**ADDENDUM NO. 1 TO LBI-38867
(PCDR)**

This addendum adds additional AC power connections information to supplement the paragraph "AC Power Connections" on Page 6.

120/208 3 PHASE INSTALLATION (L-N)

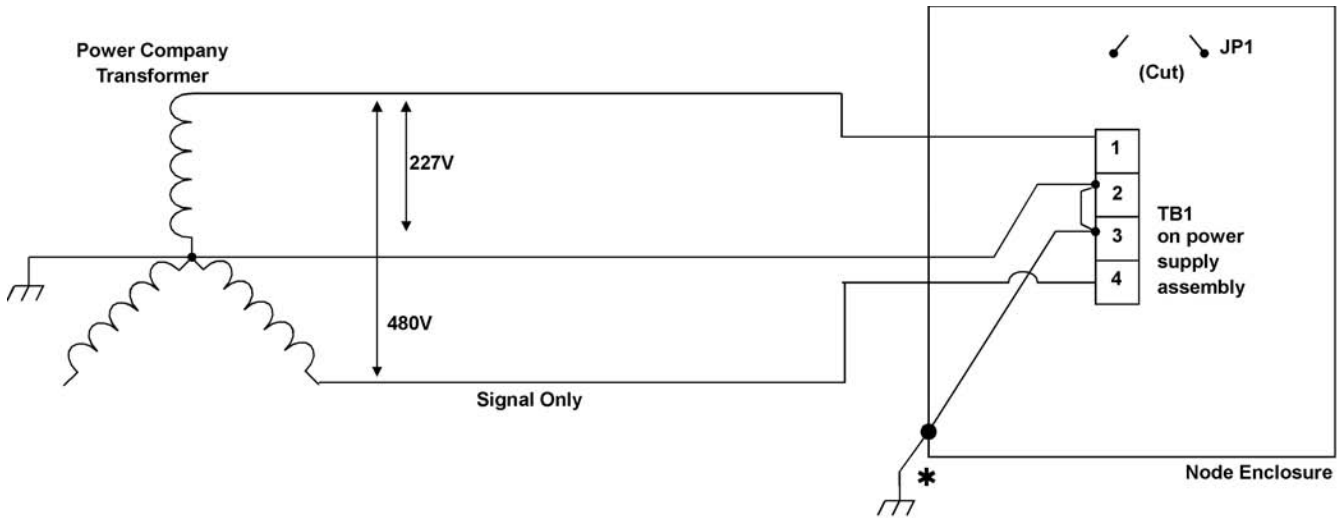
NOTE: CONNECTION OF TB1-4 TO A SECOND PHASE IS FOR SIGNAL COUPLING PURPOSES ONLY.

RECOMMENDED FOR LIGHTNING - SUSCEPTABLE LOCATIONS

* IT IS RECOMMENDED THAT THE NODE BE GROUNDED PER THE NEC (National Electric Code)

227/440V 3 PHASE INSTALLATION (L-N)

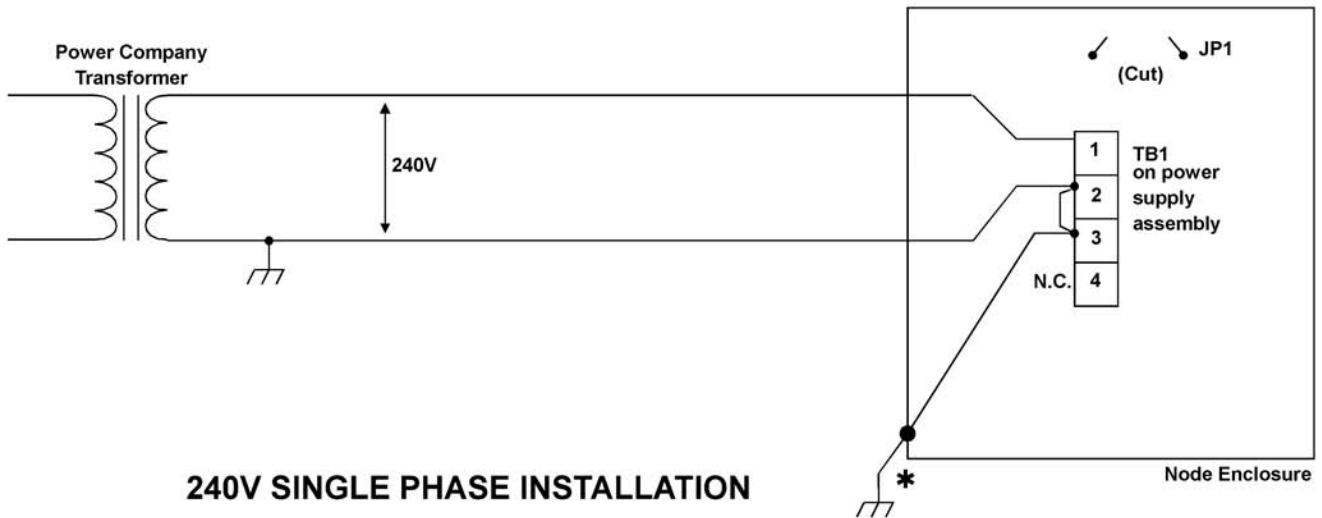
NOTE: CONNECTION OF TB1-4 TO A SECOND PHASE IS FOR SIGNAL COUPLING PURPOSES ONLY.

120/208V 3 PHASE INSTALLATION (L-L)

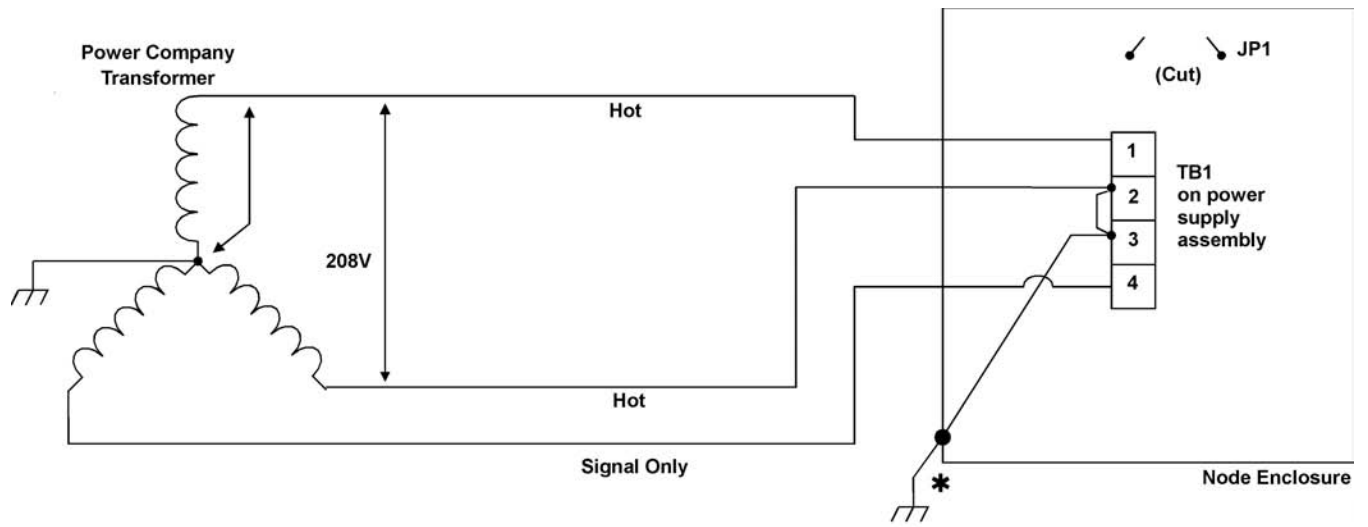
NOTE: CONNECTION OF TB1-4 TO A SECOND PHASE IS FOR SIGNAL COUPLING PURPOSES ONLY.

NOT RECOMMENDED FOR LIGHTNING SUSCEPTIBLE AREAS. USE L-N CONNECTION FOR BEST LIGHTNING IMMUNITY.

*** IT IS RECOMMENDED THAT THE NODE BE GROUNDED PER THE NEC (National Electric Code)**
